Cycle Superhighway 7

Part 2, Southern Section - Civils Works - Temporary to Permanent

Stage 1 Road Safety Audit Report

Ref: 4351/010/A24/TLRN/2024

3.12 DRAWING NO. CS7-TFL-010-10_03-DRG-TR-00001

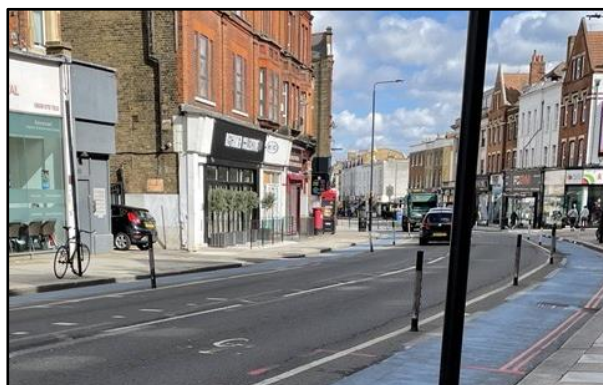
Location: O – Northbound parking bay outside No.98 - 100.

The positioning of the proposed parking bay, when occupied, may:

- Restrict visibility for road users emerging from the private access, increasing the risk of collisions between emerging road users and southbound mainline traffic.
- Restrict visibility for emerging road users at the northern most extents of the bay, due to the curve in the carriageway alignment at this location, increasing the risk of collisions between emerging road users and northbound mainline traffic. This is especially of concern as cyclists will also be merging into the main traffic lane at this location as well.

Ensure the parking bay (when occupied) does not restrict visibility or create conflicts between road users. It may be necessary to relocate the bay.

Design Organisation Response	Accepted
------------------------------	----------

Agreed. Please note both north and south bound kerbside Loading with Disabled bays are to be implemented in Part 1 and have as such already been RSA audited and responded to – please see part 1 RSA audit. Both bays were added at the instruction of IDP Sponsorship.

This bay was added following a meeting between TfL, the MP and local business owners, where the latter explained the operational issues, they were now facing. We agreed to provide a loading/disabled bay on each side of the road to support the ongoing service arrangement – note that there is no access to the rear of the properties. The location of the bay was selected because of best visibility for cyclists and traffic, and to minimise the number of times a cyclist moves between the cycle lane and traffic lane. Agree with designer comments.
